Access Compliance Report

Public Rights-of-Way

(Pedestrian Signals)

Intersection ID: N/A	Main Street:	Cross Street: N/A	Location: N/A
ADA ID: 37553F7CF08F	Signal Type: Two Push Buttons-Non APS	Overall Compliance: No	Severity Score: BTN 1:N/A BTN 2: N/A No BTN: N/A
Codes/Mitigation Info/Possible Solution		Field Measurements/Component Compliance

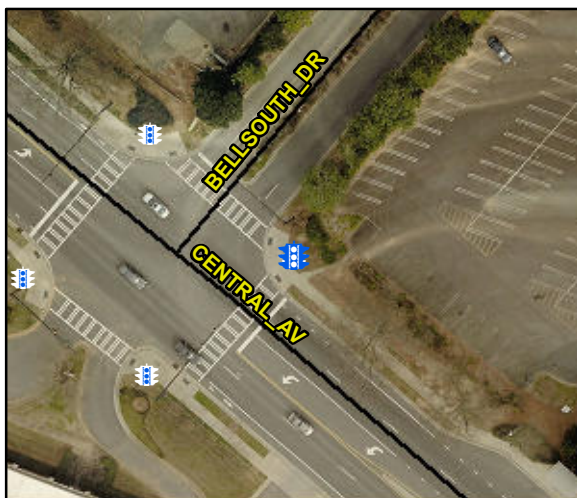
Surveyor Notes: B1 TEXT HT 7/16, B2 TEXT GT 3/8

PROW/ADA: R410.6, TMUTCD 4e.08, R404.2, R404.3, R406.2, R209.1,

Possible Solutions: Replace Signal Push Button With APS Button on New Post. Remove & Replace Sign.
